This letter is to inform you that a change in lid seal epoxy will be made to the products described herein. This notification is for your information and concurrence.

## DESCRIPTION OF DESIGN AND/OR PROCESS CHANGE

**Figure 1. Cross section of a GaN HEMT using prior epoxy.**

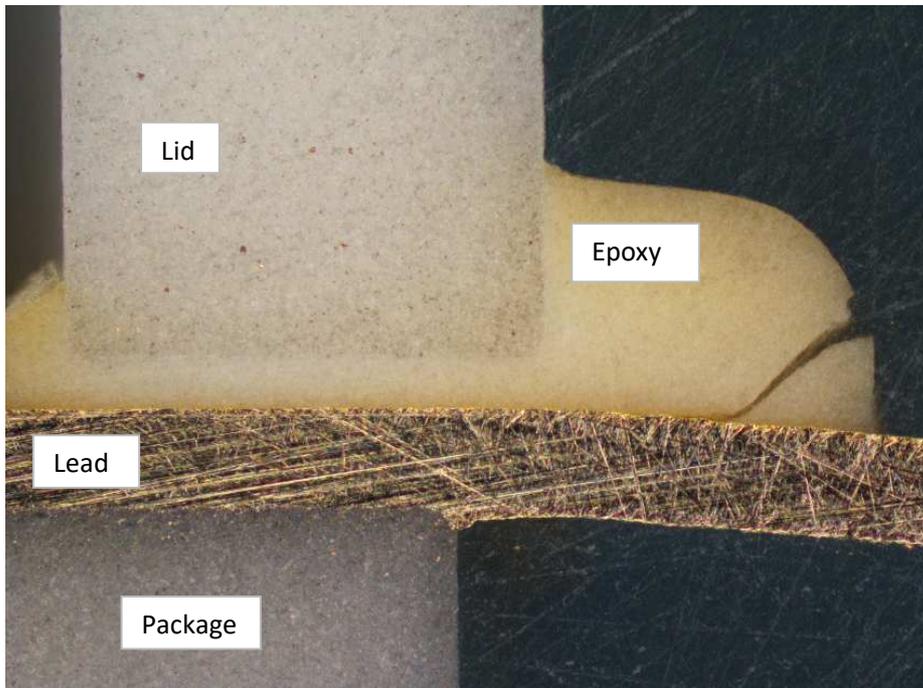
Manufacturing of the device can result in a small crack in the lid-seal epoxy, but only on the sides with the leads. This crack does not impact the electrical or mechanical performance of the device. The separation occurs further away from the package wall and does not impact the bond line of the seal of the lid to the package. This is a cosmetic issue only.

See cross section. Figure 1.

Engineering developed a solution to this occasional cosmetic cracking, by using a different type of lid-seal epoxy. This new lid-seal epoxy can appear to be light amber in color. The prior epoxy color is off-white.
